02nd August 2023

Attention: Peter Princi
Peter Princi Architects
PO Box 615,
Frenchs Forest NSW 1640

RE: Car Park Assessment
10 Florida Road, Palm Beach

Figure 1 - Proposed Plan (Source Plans prepared by Peter Princi Architects)

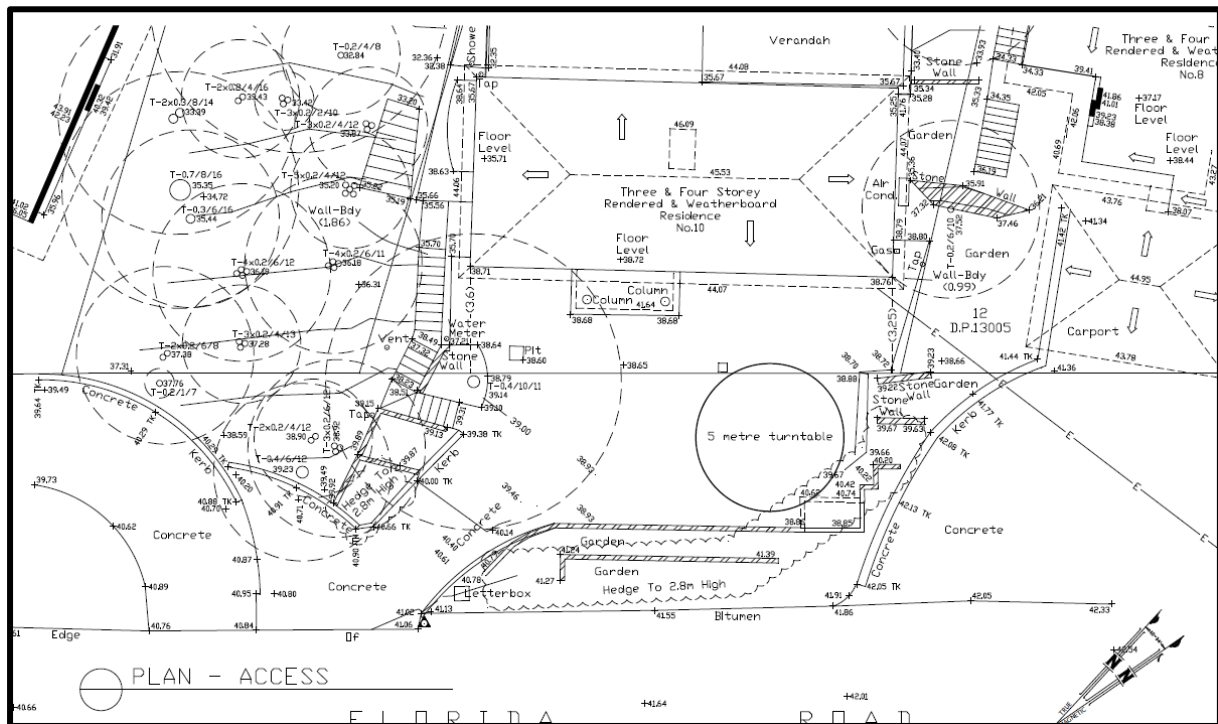
As part of the proposal, the existing car space servicing the residential dwelling will be retained. A review of the proposed plan indicates, the car space has a minimum parking space width of 3.0 metre and thereby, meeting the requirements of the Standard.

For vehicles exiting the car park, we recommend the area specified in Figure 1 is kept clear of any obstructions.

In relation to the driveway width associated with the Domestic Dwellings Clause 2.6.1 of the AS2890.1-2004 recommends a minimum width of 3.0 metres. The review of the plan indicates the proposed driveway width is in excess to 3.0m and therefore considered compliant.

DRAWING TITLE- B85th VEHICLE TYPE ACCESSING CAR SPACE

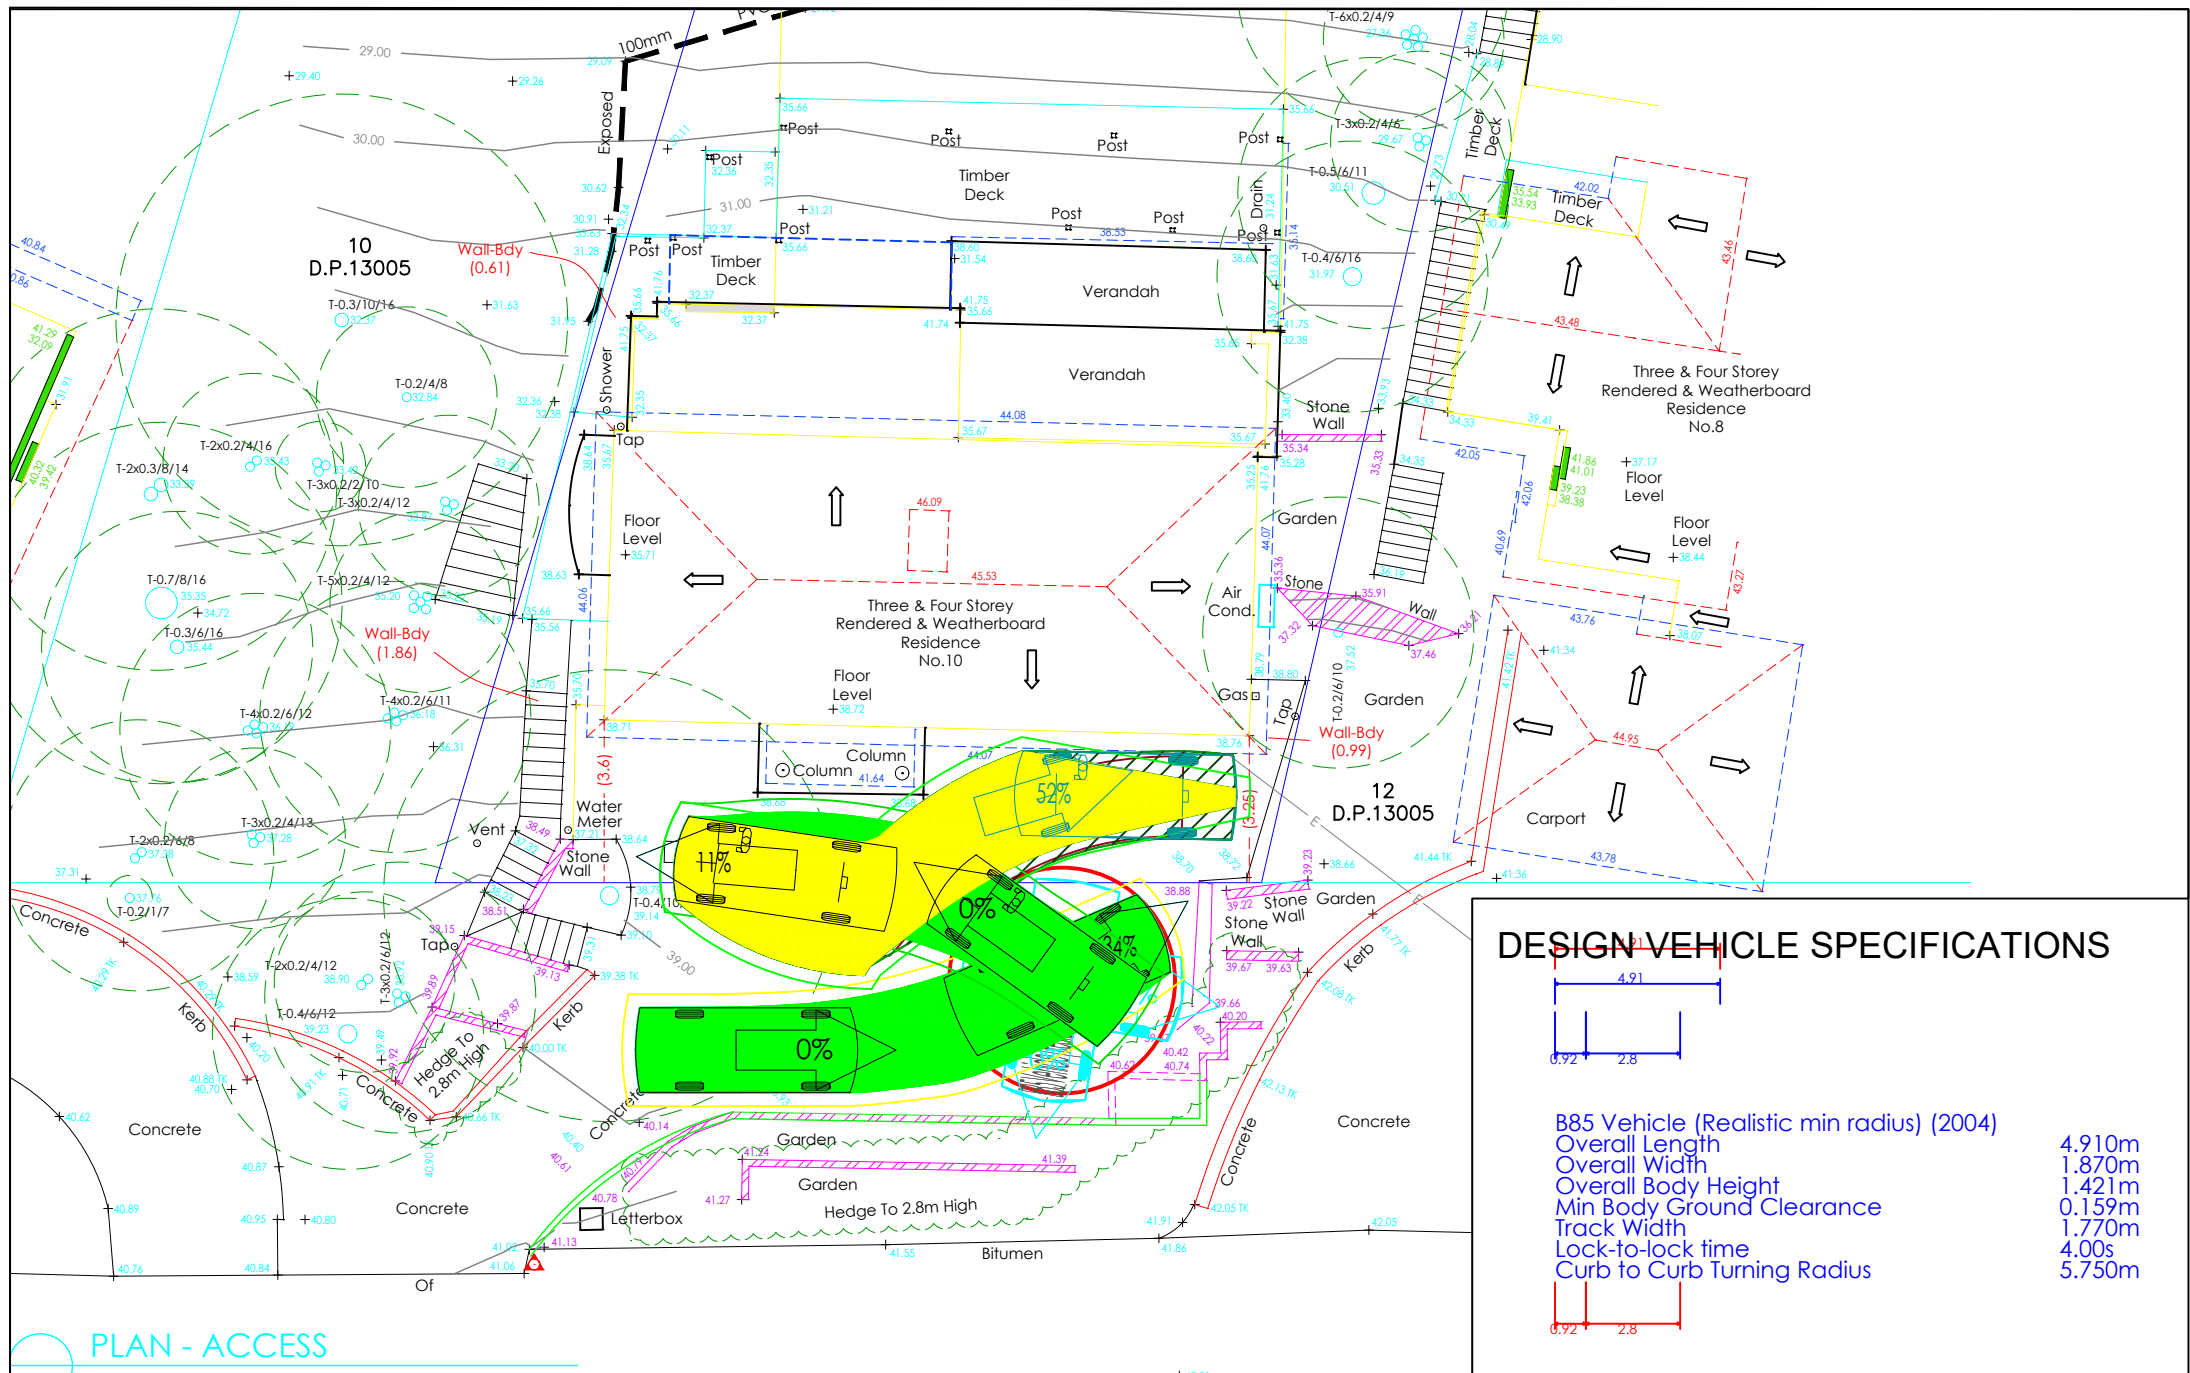
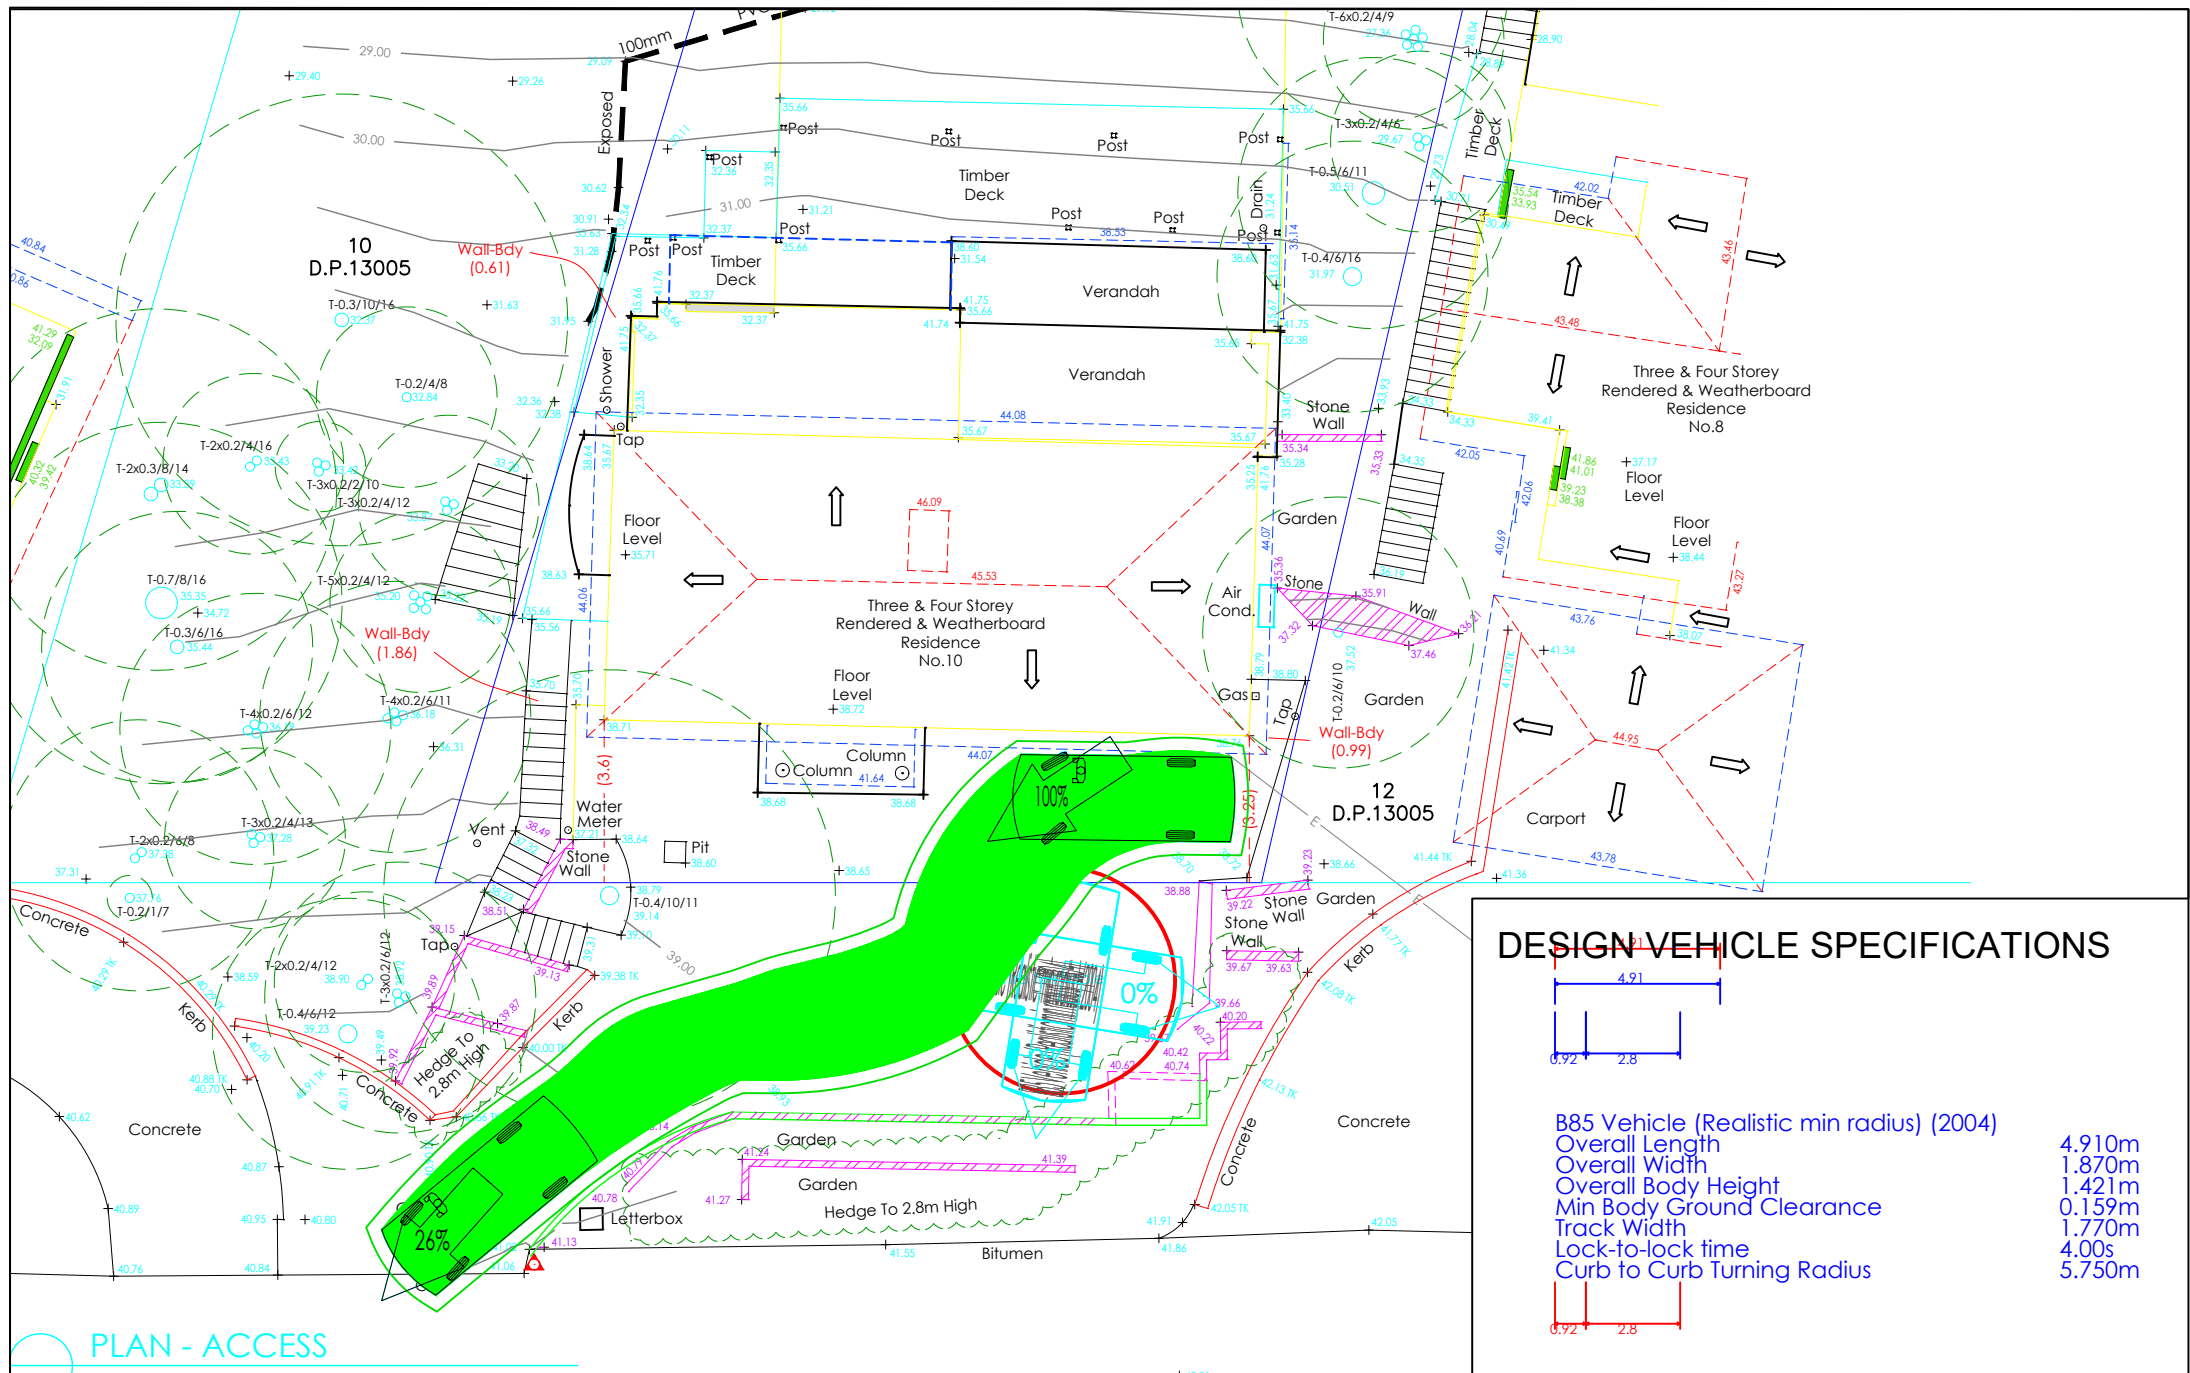
The swept path assessment concluded for accessing car space, the resident enters in forward direction and to turn around and exit in forward direction, the resident will require the turn table to manoeuvre to enter the site whereas, the exit can be achieved with a single manoeuvre.
